Access Compliance Report

Public Rights-of-Way

(Curb Ramps)

Intersection ID: 6813	Main Street: CHESAPEAKE_DR	Cross Street: SNYDER_ST	Location:	NW
ADA ID: 16951DE104B9	Ramp Type: Perp	Initial Pass/Fail: Pass	Overall Compliance: No	Severity Score: 10

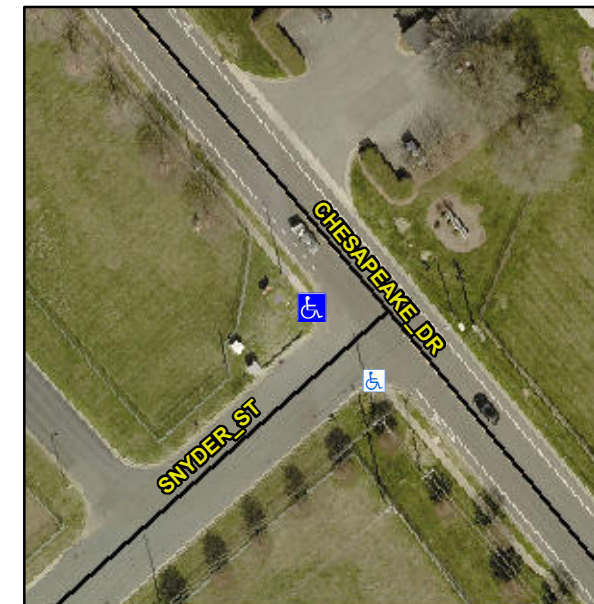
Not Found, R304.2.1, R304.2.2-Perp, R304.3.2-Para, R304.5.3, R305.2

Remove & Replace Entire Ramp.
